# Summary and Analysis of Comments: Control of Emissions from Highway Motorcycles

EPA420-R-03-016  
December 2003

Assessment and Standards Division  
Office of Transportation and Air Quality  
U.S. Environmental Protection Agency

**Figure 4.2-1**  
**On-Highway Motorcycle Sales**  
 (Source: Motorcycle Industry Council)

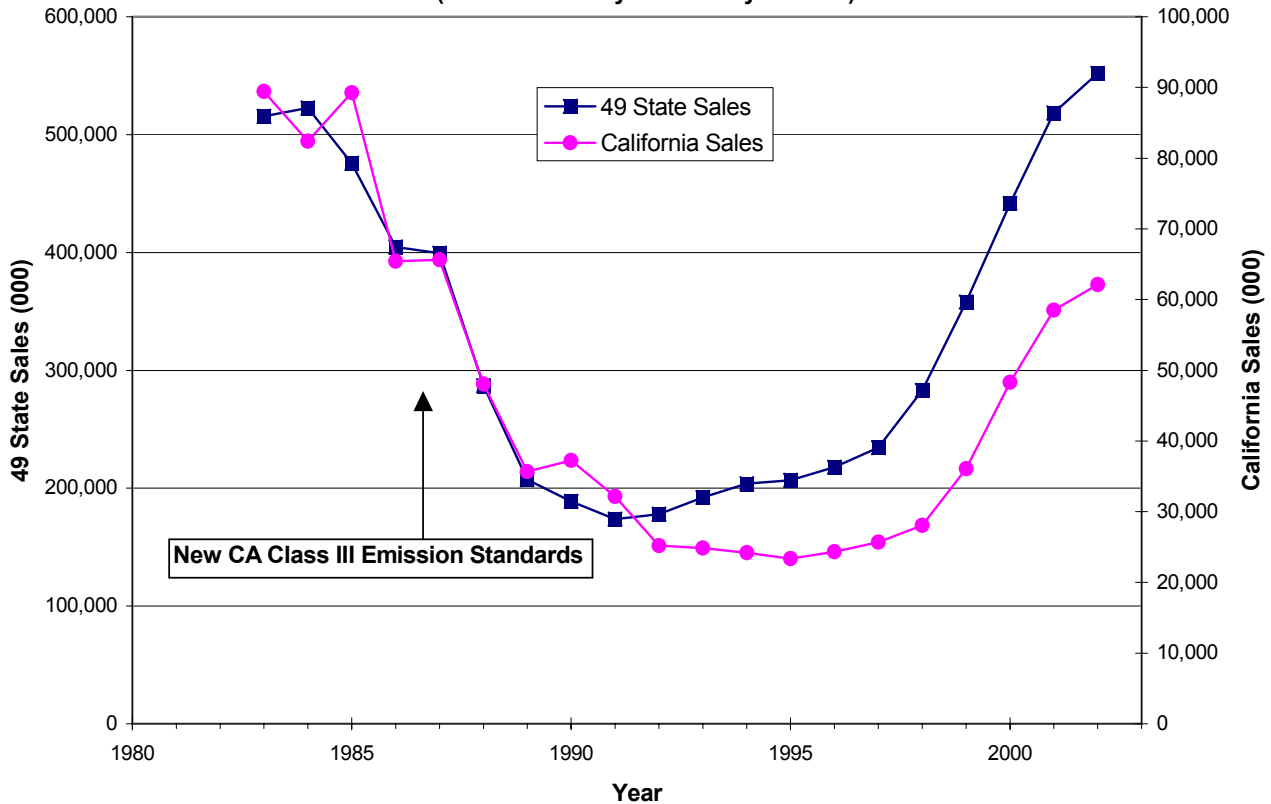
In a letter to EPA dated June 18, 2003, the MRF reiterated their belief that “over-regulation is the only plausible explanation for the variance between California and the other states.” In the letter the MRF cites the registration data presented previously in their written comments on the NPRM, and they also cite the experience in California with emission regulations for off-road motorcycles, ATVs, and personal water craft, where product availability was limited and dealers were adversely impacted. The letter also cites a story in Motorcycle Product News in which some small motorcycle manufacturers who dissolved operations in 2000 cited California regulations as one of the reasons for leaving the market.

In addition, there appears to be an error in the MRF’s calculations regarding a reported decline in sales in California. The MRF analysis, in attempting to project the potential impacts of the proposed standards, states that “...motorcycle sales begin to fall at a rate of 7 percent a year (as they have in California since 1996)...” However, they provide no evidence that California sustained adverse sales impacts at this rate. First, they only provide registration data, not sales data. Second, the registration data presented in Table 10 of the MRF analysis indicates a decline in registrations of 7.7 percent from 1996 to 2001 (or an average of about 1.5 percent per year). Consequently, we can not accept their statement regarding a sales decline in California. In fact, sales trends and patterns in California have closely mirrored sales in the rest of the U.S. for the period 1983 - 2002 for which we have data for both California and the U.S. total. In general, sales declined throughout the U.S. from the early 1980's until the early 1990's, but have been increasing since about 1991-1992. As can be seen in Figure 4.2-1 below, historical sales trends in California from 1983 to 2002 have closely mirrored sales in the rest of nation.

California in the period 1987 - 1990 (the years nearest the 1988 change in emission standards in California), while falling, were not falling as severely as in the remaining 49 states in percentage terms. In the early to mid-1990's sales in California were not doing as well as in the rest of the U.S., but it is well-documented that a recession in that time period hit California particularly hard. For example, for the first time in several decades the growth in California's population was outpaced by the national population growth rate in the early to mid-1990's. However, while a multi-year decline in sales nationwide turned around into positive growth in 1992 in the U.S., this was not the case in California, which continued to experience declines through 1995. In 1992 in particular, sales dropped more than 20 percent in California. The California mandatory helmet law went into effect on January 1, 1992. Motorcycles meeting the newest 1988 California emission standards would have started selling in 1987. A decline in sales 5 years later can not reasonably be attributed to these emission standards, and the MRF is focusing on registration declines that occurred eight years after implementation of tighter emission standards in California. There is no reasonable basis to suggest that a decline in registrations in the period 1996-2001 had anything to do with emission standards that took effect in 1988. Recently, sales in California appear to be doing as well as the sales in the rest of the nation; in fact, highway motorcycle sales in California have grown at a rate equal to or significantly higher than the remaining 49 states since 1999. DealerNews (Vol. 38, No. 2, February 2002, p.304) reports that California sales of highway motorcycles grew by about 20 percent in 2001 relative to 2000, whereas the national average increase was about 17 percent. These figures are consistent with those provided by MIC.

There appear to be several factors contributing to the nationwide decline in motorcycle sales that occurred during the 1980's. Federal emission standards were stable throughout the period, and California emission standards changed only in 1988, long past the start of the sales

**Figure 4.3-1**  
**Potential Impact of Tampering on Tier 2 Emission Reductions**

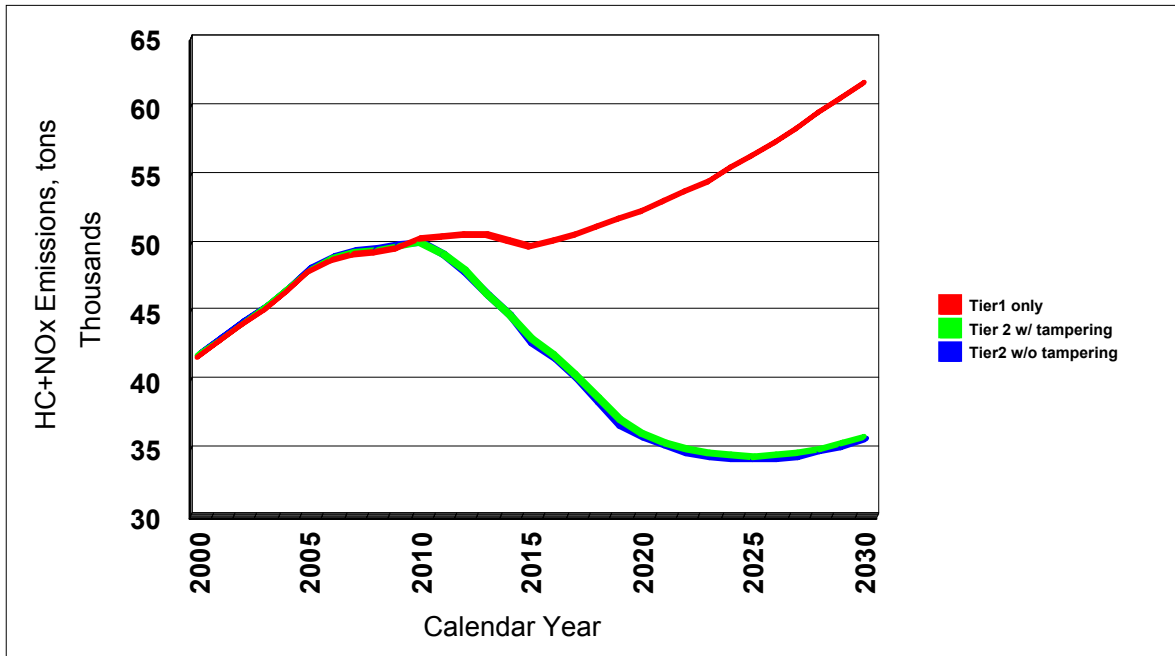
MIC stated that emission standards based on widespread use of catalysts would result in less emission reductions than anticipated due to tampering. Specifically, they were concerned that owners would remove OEM exhaust systems equipped with catalysts with non-catalyst aftermarket exhaust systems.

MIC did not provide any estimates as to the level of tampering they believe occurs in the current highway motorcycle fleet, nor did they indicate which segments of the market or which users would be more inclined to tamper with emission control devices. However, even if they had, that information might be of limited value in estimating future practices. As described in section 7.1 of Chapter 7, we provided several reasons why we do not believe there will be significant levels of tampering (e.g., catalyst removal) when the Tier 2 standards take effect. First, catalyst technology is used on 36 out of 162 current motorcycle models and there has been no evidence presented that catalyst removal is common. Second, we expect the standards will result in the widespread use of fuel management and emission control technologies, such as fuel injection, catalysts, and pulse air systems. Removal or adjustments in these systems could not only have an adverse impact on emission rates, but also would adversely impact performance, maintenance, or durability. With the Tier 2 standards being required in California two years before they are required in the remaining 49 states, we expect that the adverse effects of tampering on performance will become common knowledge based on the manufacturers' education efforts and user experience. Third, we also anticipate and expect that during the design and development process motorcycle manufacturers will take into consideration the possibility of consumers removing emission-related parts in use and develop motorcycle models and corporate strategies that will help to ensure that tampering is discouraged and limited. Fourth, we expect that catalysts will be used on only about one-half of Class III motorcycles required to meet the Tier 2 standards. Finally, because it is illegal to manufacture, sell or install a part that the manufacturer, seller or installer knows or should know will be sold or used in a manner that defeats the emission control system, and given the economic desire of parts manufacturers and dealers to continue to sell their products, we believe manufacturers will build compliant aftermarket parts.

While we believe it is speculative to attempt to quantify the potential impact of tampering on the emission benefits of the new standards, we have performed a sensitivity analysis using conservative assumptions, for the sake of argument. We have conservatively assumed that ten percent of motorcycles are tampered with in the first year of the Tier 2 standards, five percent in the second year, and one percent in the subsequent years. We have assumed that the catalyst is removed from the motorcycle resulting in a doubling of both the HC and NO<sub>x</sub> emissions. Given these assumptions, the estimate loss of benefits over the first ten years after the Tier 2 standards take effect is approximately 3,400 tons of HC+NO<sub>x</sub>. This is about a five percent loss in benefits from the Tier 2 standards. Figure 4.3-1 presents the emission inventories showing the baseline (Tier 1 standards only), and the Tier 2 inventories assuming no tampering and assuming the tampering levels described above.
